CERTIFICATE OF APPROPRIATENESS

Property: 1330 Cortlandt Street, lot 22, block 168, Houston Heights Subdivision. The property includes an altered historic 4,301 square foot, two-story wood frame single-family residence and a detached one story accessory structure situated on a 9,900 square foot (75' x 132') interior lot.

Proposal: Alteration – *Revision*: The applicant was granted a COA in on December 12, 2013 to construct a two story addition to the rear of a two story contributing residence. The applicant now proposes the following revisions to this COA.

NORTH SIDE ELEVATION

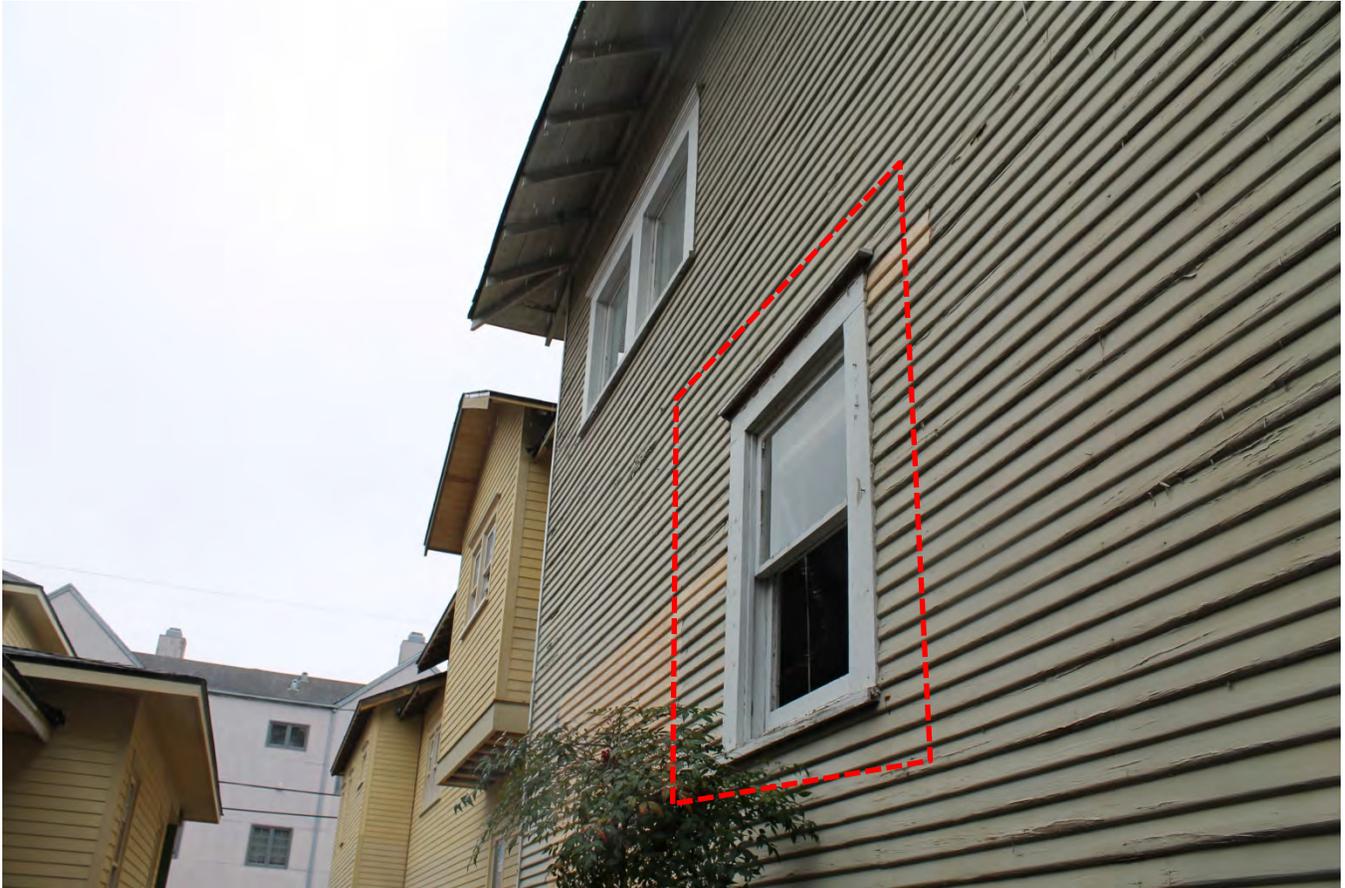
EXISTING WINDOW TO FEATURE FIXED SHUTTERS

Windows/Doors: Existing north facing first floor window, second from the front wall of the house, will be clad with a pair of fixed painted wood shutters.

DOOR SCHEDULE

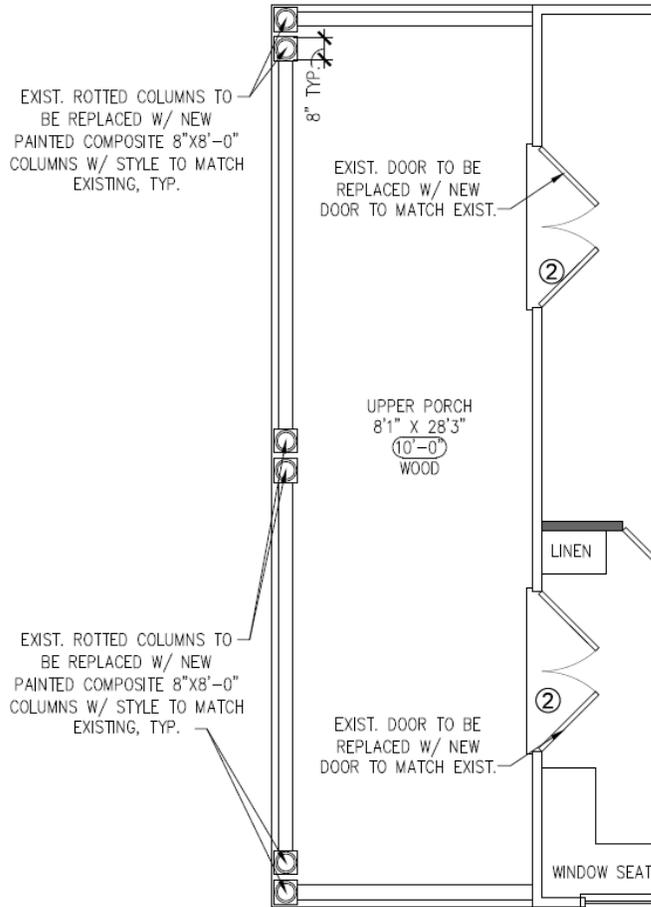
PROPOSED DOORS WILL MATCH EXISTING

The existing non-original façade features three wood divided lite doors: One single door flanked by a pair of sidelites and two pairs of French doors on the second floor balcony. These doors will be replaced with new wood divided lite replacement doors.
